ADDENDUM #3

August 27, 2025

**CRAWFORDSVILLE READINESS CENTER MODERNIZATION
INDIANA NATIONAL GUARD
CRAWFORDSVILLE, INDIANA**

IFB NO: MDI-SAB-26-B-013

ABI 1
A110

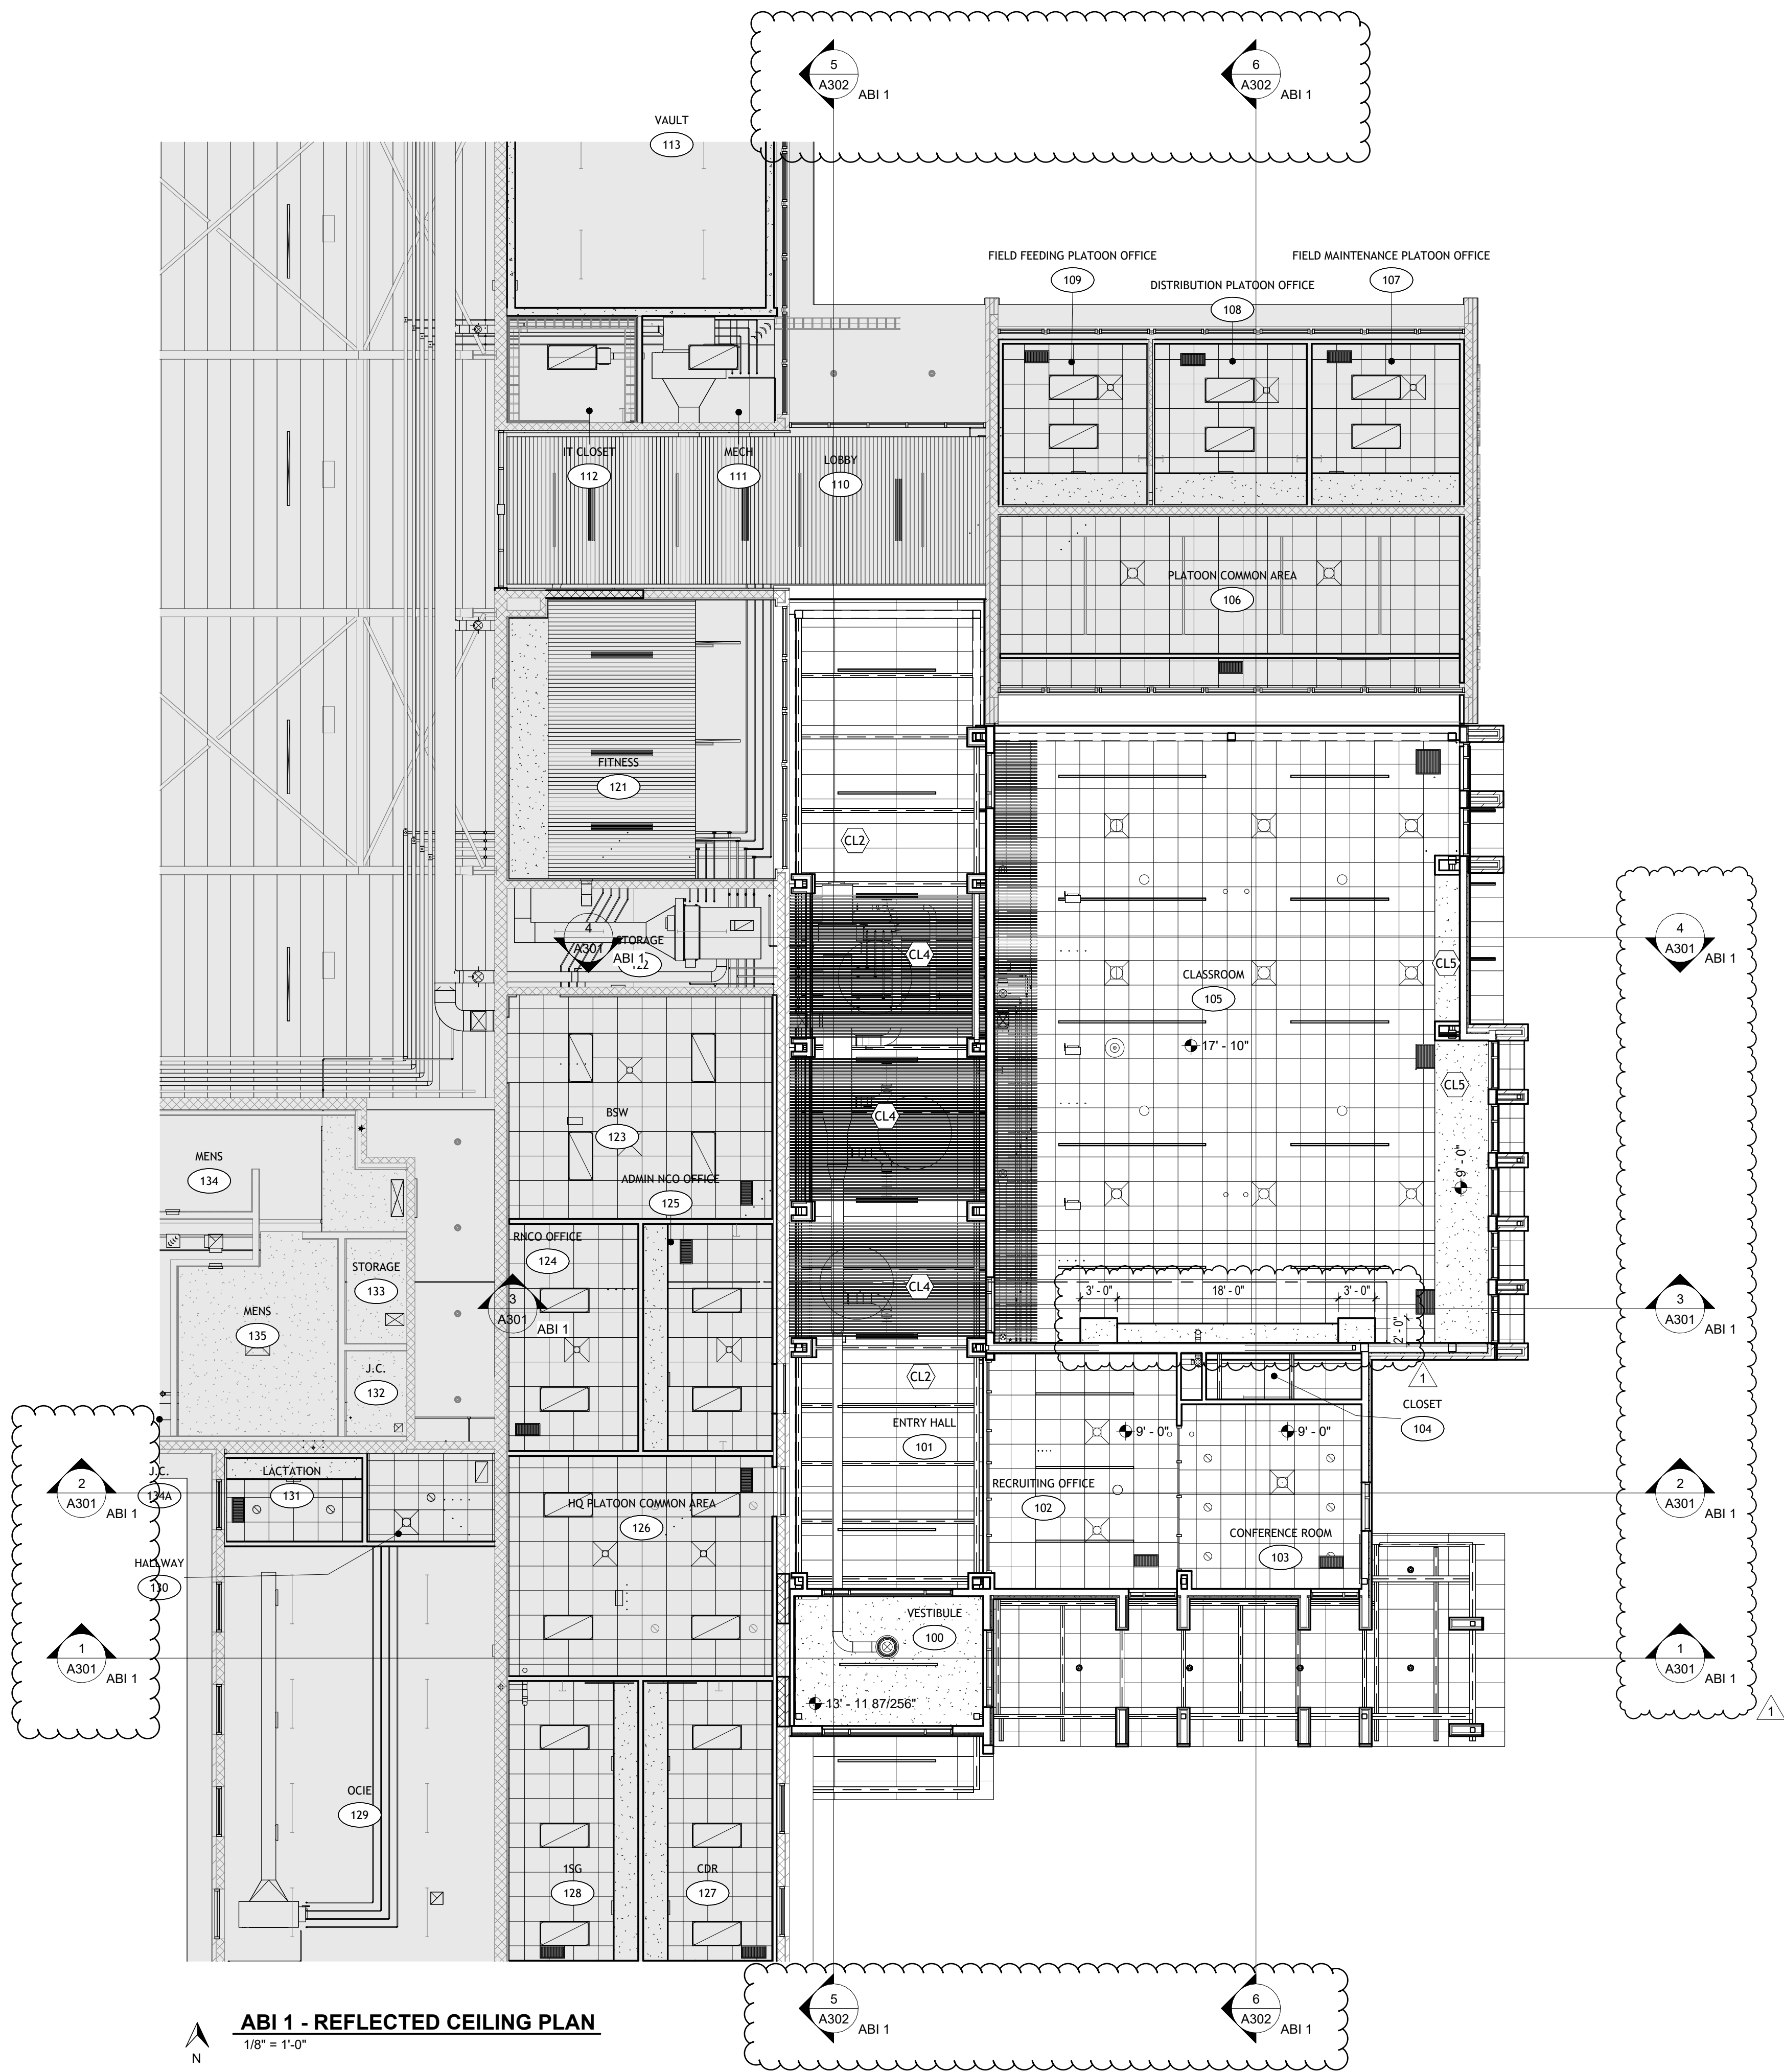
- Response:** More than one expansion joint style is required. Bid per the details.
17. **Question:** On ABI1 A110, it appears that Vestibule 100 has a drywall ceiling in there, but there is no tag saying what that ceiling is supposed to be. Please confirm this to be a drywall ceiling?

- Response:** Please Refer to Sheet ABI 1 A322, attached to this Addendum for details.
19. **Question:** On ABI 1 A110, it calls for CL2 throughout the entire Entry Hall 101 space, which the legend tells us it is existing and gets repainted. With this being a new addition, it will not be existing- can we get product numbers for these metal panel ceilings?

- Response:** This is a drywall ceiling.
18. **Question:** Section 1-1 on ABI 1 A301 - Is the woodworks ceiling everything that is highlighted in the below screenshot? Can we get a product number on which woodworks grille they want? Armstrong offers several options that vary in price and installation method. If the highlighted portion is the desired area they want the wood ceiling, then they would have to choose a product number that could be installed both vertically and horizontally?

- Response:** Metal panels are used for the column surrounds and the bulkeads connecting the column surrounds only. Outside of this area, the exposed structure is to be painted. See ABI 1 A321 for details.
